Numerical Groundwater Transport Model Development Lockheed Martin Beaumont Site 1 Beaumont, California

Subject: Submittal of the Revised *Numerical Groundwater Transport Model Development, Lockheed Martin Beaumont Site 1, Beaumont, California*

SUBJECT: SITE 1 NUMERICAL GROUNDWATER TRANSPORT MODEL
DEVELOPMENT, BEAUMONT, CALIFORNIA, DATED APRIL 27, 2010

**RESPONSE TO COMMENTS - NUMERICAL GROUNDWATER TRANSPORT MODEL DEVELOPMENT
LOCKHEED MARTIN BEAUMONT SITE 1, BEAUMONT, CALIFORNIA, DATED OCTOBER 2010.**

Figure 3-2
Geologic Cross Section A-A'-A''

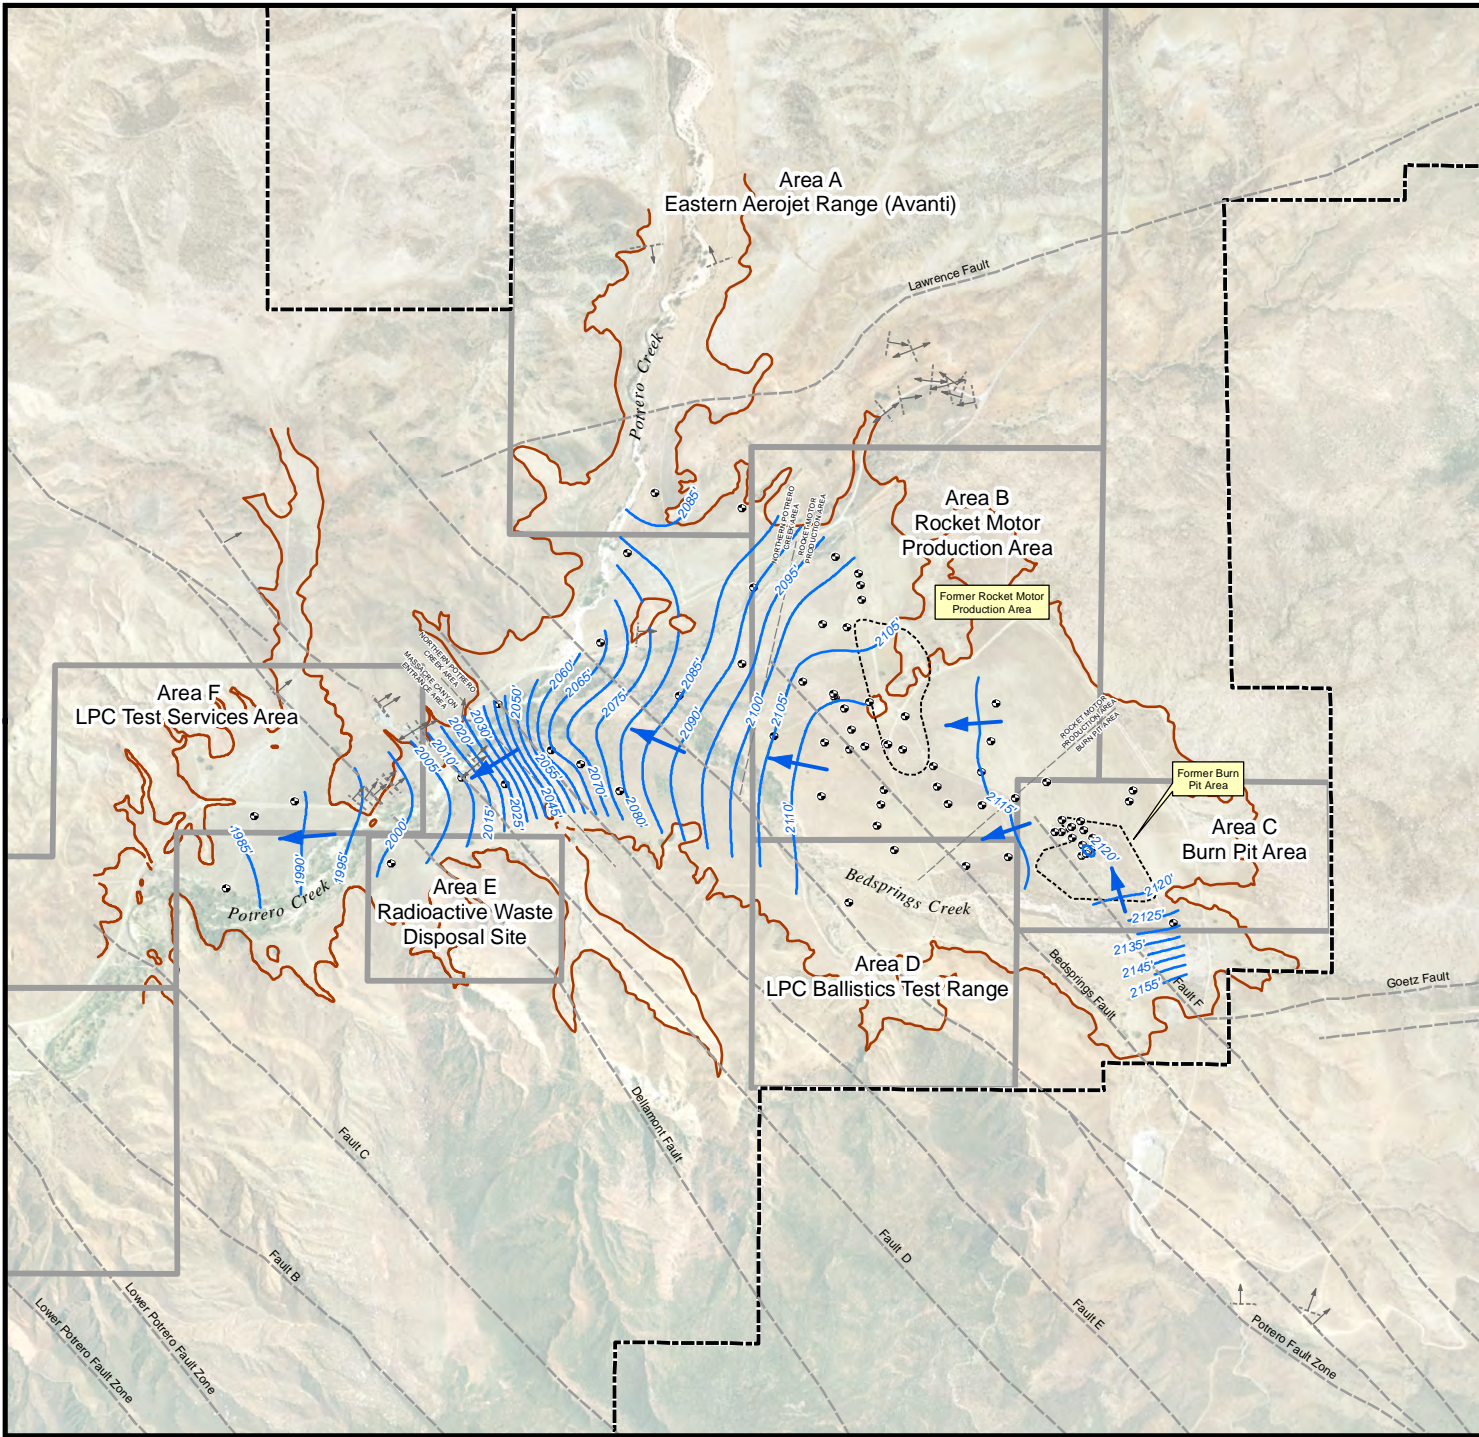
1. **FIGURES:** Beginning with Figure 3-2 and many figures thereafter, the illustrations are unclear and difficult to read. The document should be resubmitted with legible figures.
- 2 **Page 3-13:** It should be specified if Figures 3-6 through 3-9 depict current and/or historical concentrations.
3. **Page 3-32, Section 3.2.3:** "and Site F—3 is difficult . ." should be changed to "and Site **F-33** is difficult."
4. **Page 3-35:** "Given the 7,200 foot long plume at Beaumont Site 1, the longitudinal dispersivity would be estimated using methods summarized in USEPA (1998).as 50 feet, the lateral dispersivity is estimated . ." This statement should be revised to correct typos.
- 5 **Page 6-2:** Although remedial alternatives Options B and C are referenced in another document, they should be defined herein.

Comments from DTSC, dated February 23, 2011		
Comment	Response	Proposed Action
<p>Specific Comment #1 FIGURES: Beginning with Figure 3-2 and many figures thereafter, the illustrations are unclear and difficult to read. The document should be resubmitted with legible figures.</p>	<p>Comment noted.</p>	<p>Figures 3-2 through 3-9 will be revised to make them more readable.</p>
<p>Specific Comment #2 Page 3-13: It should be specified if Figures 3-6 through 3-9 depict current and/or historical concentrations.</p>	<p>These figures represent current conditions.</p>	<p>The text will be revised on Page 3-13 to indicate that Figures 3-6 through 3-9 represent current conditions.</p>
<p>Specific Comment #3 Page 3-32, Section 3.2.3: “and Site F-3 is difficult...” should be changed to “and Site F-33 is difficult”</p>	<p>The typographical error within the text will be revised as requested.</p>	<p>The text will be revised on Page 3-32 to indicate “and Site F-33 is difficult”</p>
